Alternative Compliance Review

Dillons Store, 1740 Massachusetts Street [SP-12-62-10]

April 20, 2011

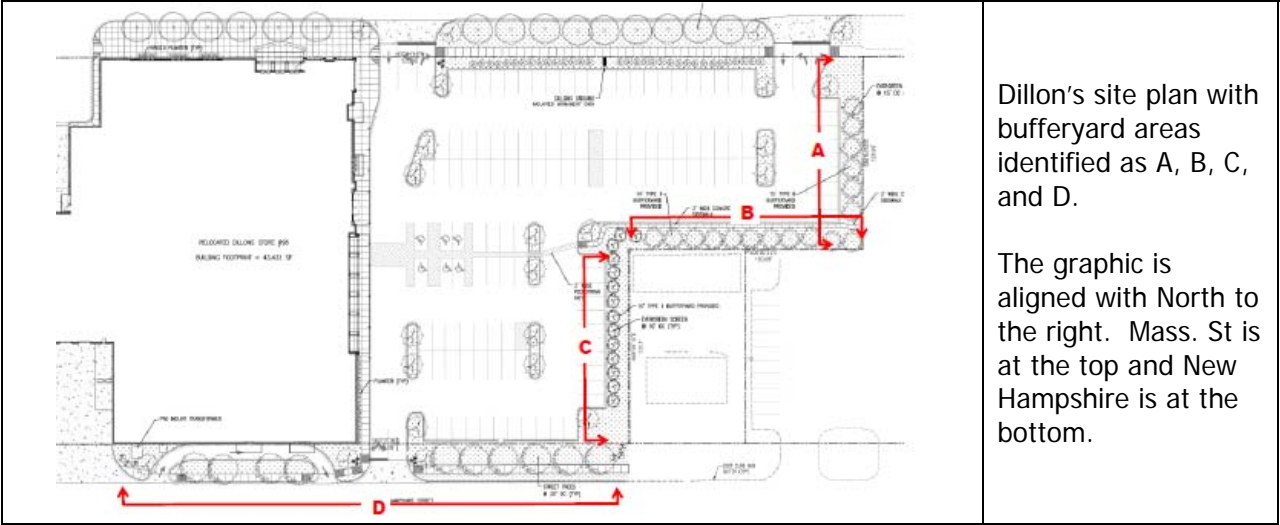
Area A: Buffer area between the parking lot and Babcock, (125 linear ft)	
Standard: Wall or Berm 4 trees/100 linear ft 1.25 x 4 = 10 trees 15 shrubs/100 linear ft 1.25 x 15 = 19 shrubs	Provided on plan:
	7 trees
	0 shrubs
Deficit: Wall or berm, 3 trees and 19 shrubs.	
Discussion: The City Horticulture Manager indicated that the evergreen species shown would create a screen which could shade out the neighboring lot. She recommended using 3 smaller evergreen species and 3 redbuds in this area. In order to provide visibility for the pedestrian walkway, trees should not be planted within 15 ft of the walkway (to the west and east) in this buffer area, but shrubs that will not exceed 3 ft in height are recommended.	
Determinatino: Approve alternative compliance from requirement to have a wall or berm in this area and to allow the reduction in the required number of trees to 7. The species in this Bufferyard should be revised as recommended by the Horticulture Manager and the 19 shrubs should be added.

Area B: Buffer between the east side of the parking lot and the west side of the apartment building and Babcock parking area. (150 ft)	
Standard: Wall or Berm 4 trees/100 linear ft $1.5 \times 4 = 6$ trees 15 shrubs/100 linear ft $1.5 \times 15 = 23$ shrubs	Provided on plan:
	Trees: 12
	Shrubs: 0, with substitution of shrubs for additional trees at rate of 3/1, the extra 6 trees = 18 shrubs for a total of 18 shrubs.
	Deficit: Wall or berm, 5 shrubs
Discussion: The City Horticulture Manager indicated that the trees would need to be placed further to the east to allow room for a 5 ft walkway in the Bufferyard. The trees should be moved as far to the east as possible while maintaining adequate separation from the sanitary sewer line. She recommended planting loripe or using mulch along the trees so mowing under the trees would not be necessary. Two trees on the north side of this Bufferyard area will be replaced with shrub plantings to increase visibility of the walkway.

Area C: Buffer between the north side of the parking lot and the apartment building. (125 ft)	
Standard: Wall or Berm 4 trees/100 linear ft $1.25 \times 4 = 10$ trees 15 shrubs/100 linear ft $1.25 \times 15 = 19$ shrubs	Provided on plan:
	Trees: 13
	Shrubs: 0, with substitution of shrubs for additional trees at rate of 3/1, the extra 3 trees = 9 shrubs for a total of 9 shrubs.
	Deficit: Wall or Berm, 10 shrubs.
Discussion: The City Horticulture Manager recommended moving the trees to the north and keeping the swale between the trees and the parking lot. She recommended replacing 4 of the evergreens at the west side of this bufferarea, near the walkway with a crabapple tree and replacing the 3 eastern evergreens with a silky dogwood as it is more tolerant of wet conditions. Feather-reed grasses should be planted in this area as well.	
Recommendation: Approve alternative compliance from requirement to have a wall or berm in this area. 10 trees are required with these recommended species: from the west to the east there should be a crabapple tree, 8 Taylor Junipers, and a Silky Dogwood at the east edge of the buffer area. Feather-reed grasses should be planted in the planting area at the east.

Area D: Buffer area along New Hampshire Street frontage. (370 ft, app.)	
Standard: Wall or Berm 4 trees/100 linear ft $3.7 \times 4 = 15$ trees 15 shrubs/100 linear ft $3.7 \times 15 = 56$ shrubs	Provided on plan:
	Trees: 11 Shrubs: 44
Discussion: The City Horticulture Manager recommended limiting the number of trees in this area to 11 to provide sight distance and adequate growing space. Single Stem River Birch are recommended for the area containing the swale as they are water tolerant species. Space is available for additional shrubs; however, feather-reed grasses or other water tolerant plantings should be used in the swale. Shrubs and ornamental plantings should be provided to screen the drive-thru lane.	
Determination: Approve alternative compliance from requirement to have a wall or berm in this buffer area. Approve alternative compliance to allow 11 trees with species as recommended by the City Horticulture Manager. 44 plantings should be added in this area, with water tolerant species such as feather-reed grasses in the swale and shrubs, and ornamental plants along the drive-thru lane.

The Planning Director approves Alternative Compliance from the requirement to install a wall or berm in Bufferyard areas A-D.

The Planning Director approves Alternative Compliance to allow 7 trees in Area A (buffer area between Dillons and Babcock) with species as recommended by City Horticulture Manager.

Alternative compliance not approved for shrubs, the 19 required shrubs shall be provided.

The Planning Director approves Alternative Compliance for Area B (buffer area west of Babcock parking lot and apartment building) to allow 10 trees and 5 shrubs (the northern 15 ft of the buffer area will contain the 5 shrubs and no trees), with the trees in this buffer area being located as far to the east as possible while maintaining adequate separation from the sewer line, per the City Utility Engineer.

The Planning Director approves Alternative Compliance from landscaping required in Section 20-1005(e) for Area C, buffer area between the north side of the parking lot and the 6 unit apartment building to allow 10 trees per the City Horticulture Manager recommended species. Feather-reed grasses or other water tolerant plants should be planted in the eastern portion of this Bufferyard.

The Planning Director approves Alternative compliance from landscaping required in Section 20-1005(e) for Area D (buffer area along New Hampshire Street) to allow 11 trees and to allow the 44 shrubs plantings to include ornamental or water tolerant plants, using species recommended by the City Horticulture Manager.
